BLUE MARSH DAM  
AND  
RESERVOIR

CONDITION REPORT.

DAM, OUTLET WORKS, SPILLWAY  
& BERNVILLE PROTECTIVE WORKS.  
PERIODIC INSPECTION REPORT

SEPTEMBER 1979.

**BLUE MARSH LAKE  
INSTRUMENTATION PLAN**

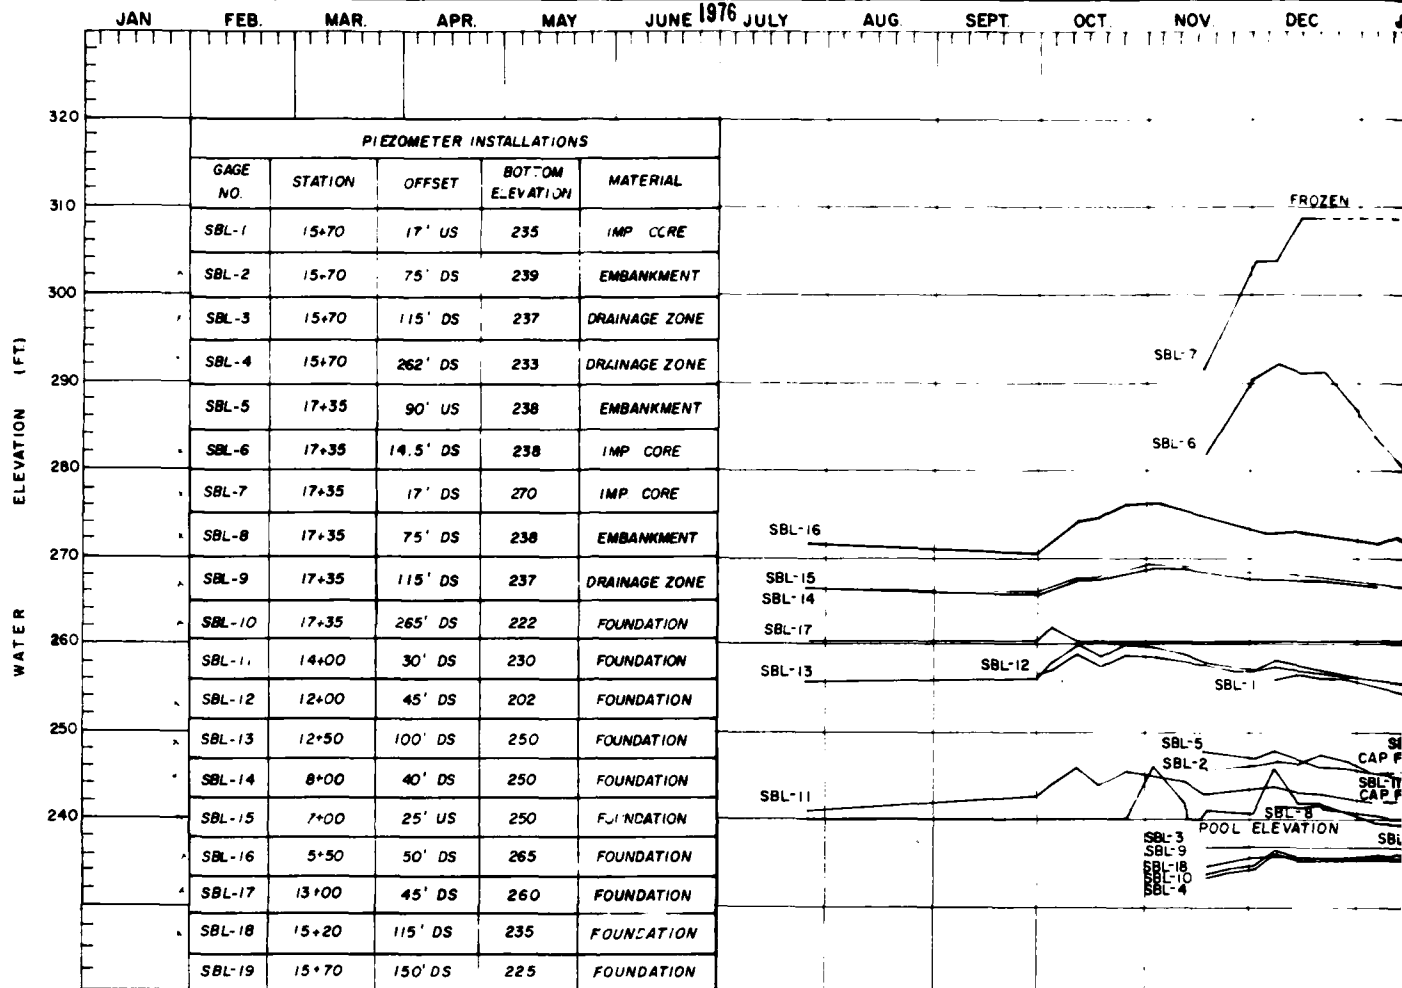
b. The seepage area noted during the first Periodic Inspection in the foundation at the downstream toe of the slope at Sta 8+00 (near piezometer SBL-14) was noted again during this periodic inspection. This wet area has shown little change in character, location or extent since the first periodic inspection which was performed prior to the filling of the reservoir. Several wet areas were also noted during these same two inspections along the upstream toe of slope on the right abutment between STA. 8+00 and 10+00. These upstream areas seem to be due to the ponding of surface water rather than seepage. The location and approximate extent of these wet areas are shown on Plate No. 1 (Instrumentation Plan). No action required.
